Proposal #06: 3897-00-69
Iron Ridge – East County Line
STH 67 – Meadowbrook Park
Drive
CTH S
Dodge County

3897-00-70, WISC 2017 096
Iron Ridge – East County Line
STH 67 – Meadowbrook Park
Drive
CTH S
Dodge County

This is Addendum No. 03, which provides for the following:

ADDENDUM NO. 03
3897-00-69 & 3897-00-70
March 9, 2017

Addendum No. 03
ID 3897-00-70
Revised Sheet 19
March 9, 2017

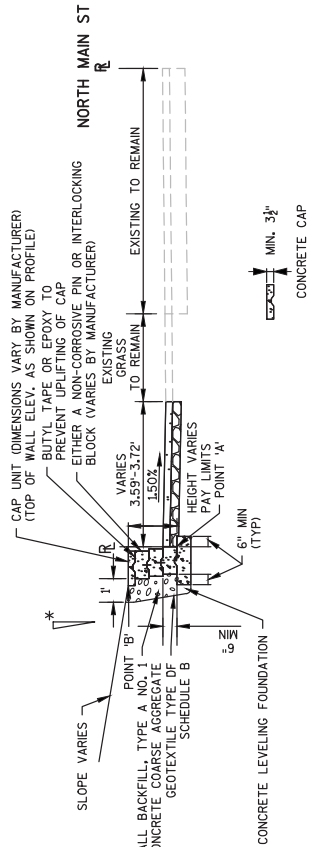
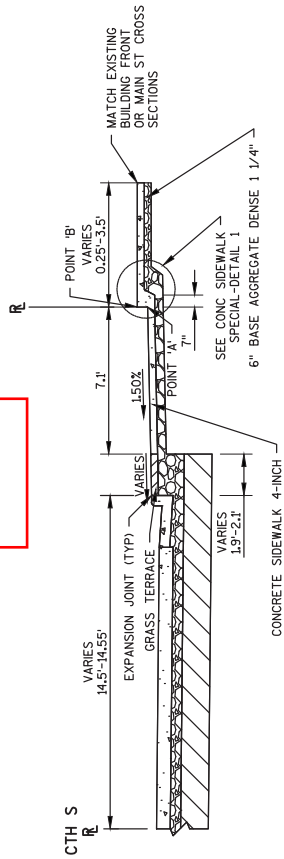
Revised Plan Sheets	
Plan Sheet	Plan Sheet Title (brief description of changes to sheet)
19	Construction Details (Renamed polymer-coated fence to polyvinyl chloride)
24	Construction Details (Renamed polymer-coated fence to polyvinyl chloride and moved fence further away from retaining wall)
26	Construction Details (Added fence to wall M detail with new name of polyvinyl chloride and moved fence to 1' behind wall)
32	Construction Details (Renamed polymer-coated fence to polyvinyl chloride)
52	Erosion Control (Renamed polymer-coated fence to polyvinyl chloride)
115	Miscellaneous Quantities (Added tack coat to mq chart)
126	Miscellaneous Quantities (Renamed polymer-coated fence to polyvinyl chloride)
149	Plan and profiles (Renamed polymer-coated fence to polyvinyl chloride)
153	Plan and profiles (Renamed polymer-coated fence to polyvinyl chloride)
159	Plan and profiles (Renamed polymer-coated fence to polyvinyl chloride)

Addendum No. 03
 ID 3897-00-70
 Revised Sheet 161
 March 9, 2017

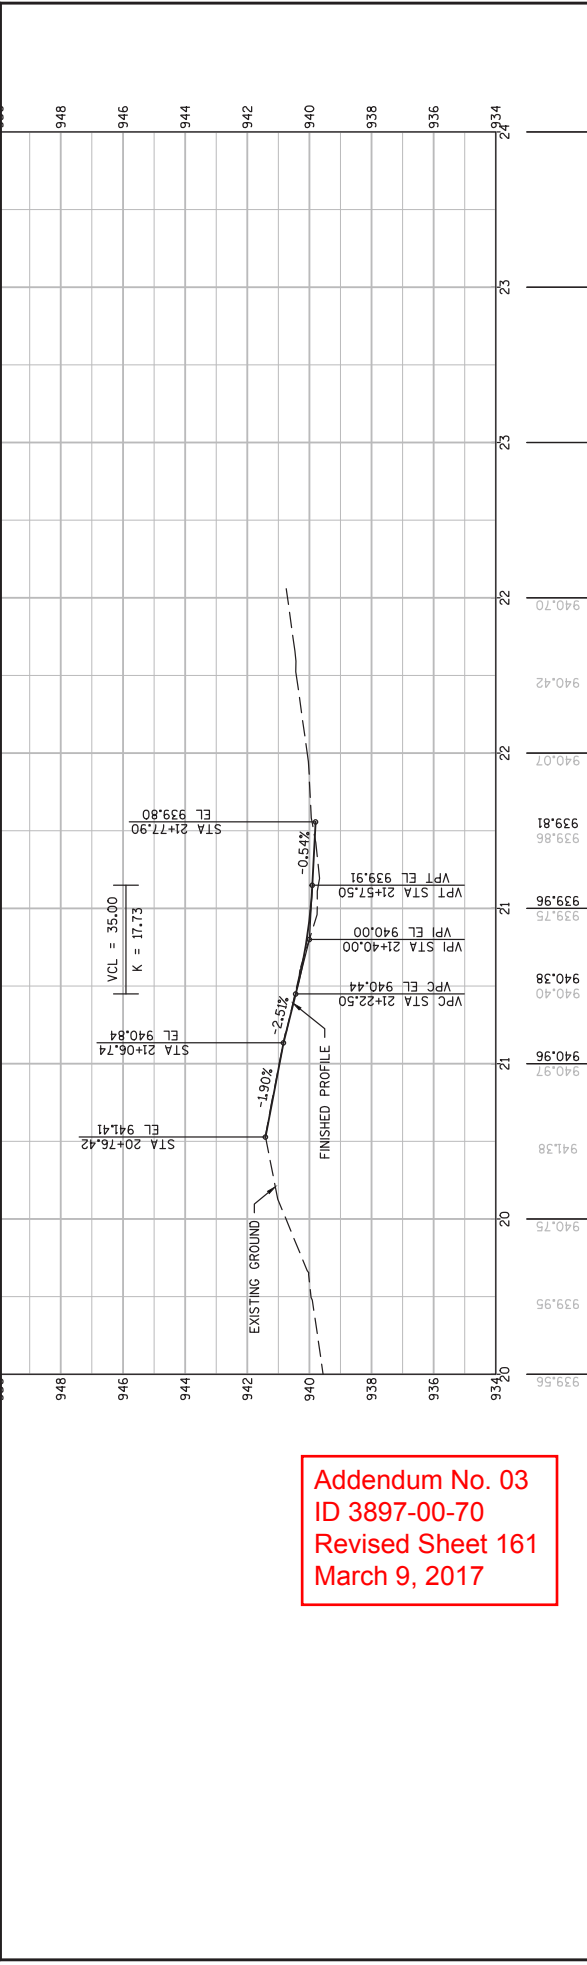
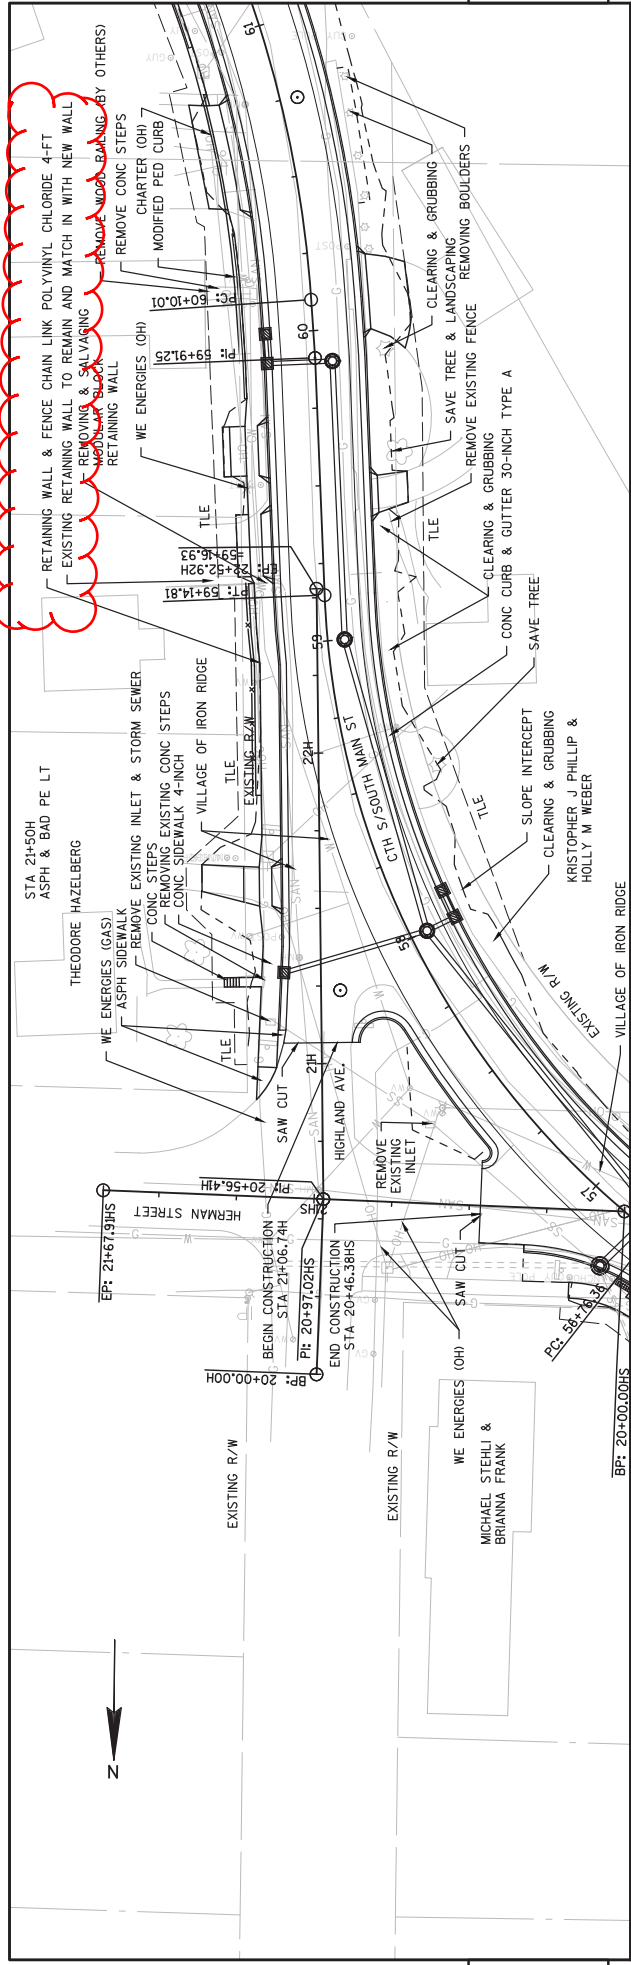
161	Plan and profiles (Renamed polymer-coated fence to polyvinyl chloride)
